TECHNICAL SERVICE BULLETIN

Number: TSB-CAS-2019-001

Symptom: Need to replace antenna or hood cover

Symptom:	Need to replace 56104567 HOOD COVER ASSEMBLY or 56104624 ANTENNA-REMOTE INTERFACE.
Products:	All SC50 models.
System:	Control system
Related/Prior TSB:	Not Applicable

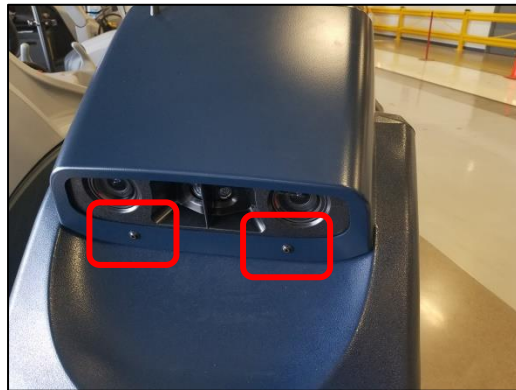
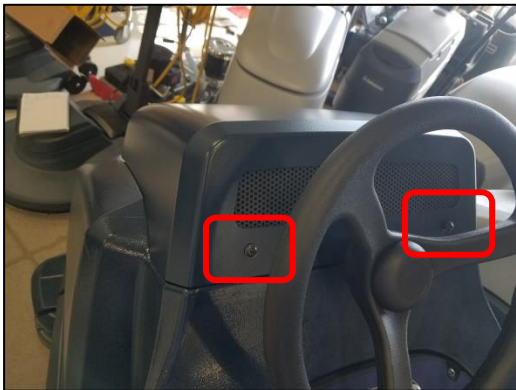
RID antenna is not functional and has been obsoleted. No service parts will be maintained for the 56104624 ANTENNA-REMOTE INTERFACE, 56104858 BRACKET-RID ANTENNA, 56104937 CABLE-ANTENNA-RID, or 56104859 SEAL-RID ANTENNA. The 56104567 HOOD COVER ASSEMBLY has been updated to remove the hole for the RID antenna. If a customer needs to replace the hood, they should remove the RID antenna and components. If a customer needs to replace the antenna or components, they should instead remove the RID antenna, components and replace the hood cover.

Parts have been made obsolete. Current 56104567 HOOD COVER ASSEMBLY without hole is being used; all hood cover stock has been updated to current design sans antenna hole. Previous antenna, bracket, seal and cable are discontinued.

First production machine with 56104567 rev G (which has no antenna hole) hood cover installed as standard equipment.

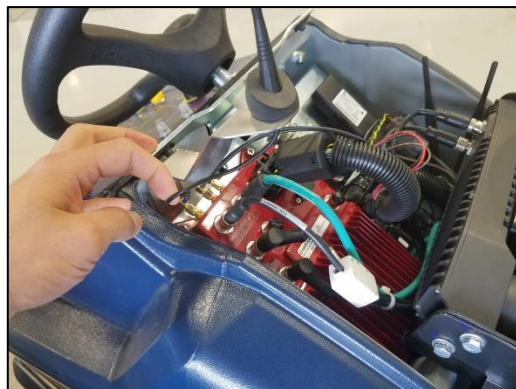
1. Using a 4 mm allen wrench, remove the 4 screws on the hood cover, then lift the cover to remove it.

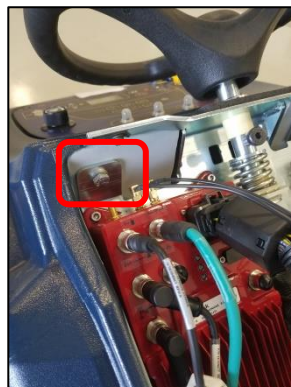
2. Using an 8 mm wrench, loosen and unplug the antenna cable.
